SERVICE BULLETIN 7

MODEL  
GLASAIR FT

DATE  
10/17/85

SUBJECT: WELDS OMITTED ON GLASAIR FT INBOARD RIB ATTACH BRACKET

FIGURE (1)

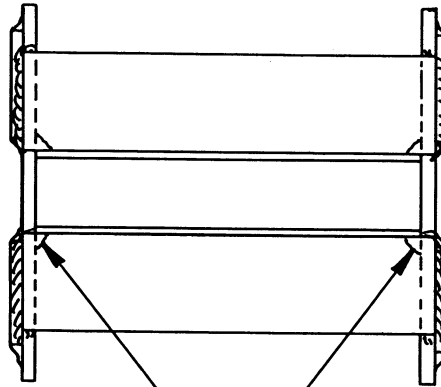
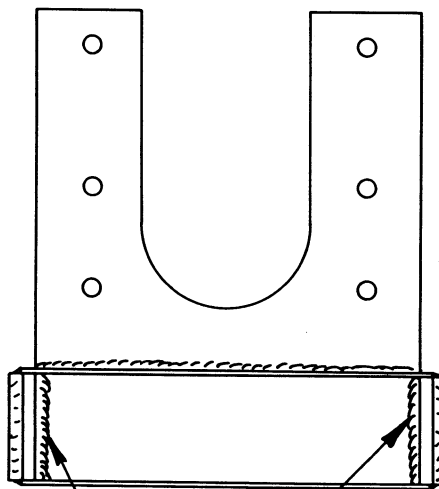
WELDS REQUIRED HERE  
(BOTH SIDES OF BRACKET)

WELDS REQUIRED HERE  
(BOTH SIDES OF BRACKET)

DESCRIPTION: The inboard rib attach bracket delivered with your Glasair FT landing gear hardware omitted four necessary welds. Without these welds, shown in FIGURE (1), the component lacks the necessary strength to withstand possible loads imposed by the landing gear.

SOLUTION: The omitted welds must be completed, using either the oxy-acetylene or gas tungsten arc welding (TIG) process, before the airplane is flown. The builder has the choice of completing these welds himself or shipping the bracket to us for welding in our shop.

Since the cadmium plating will be burned off by welding, the part must either be replated or painted for corrosion protection.
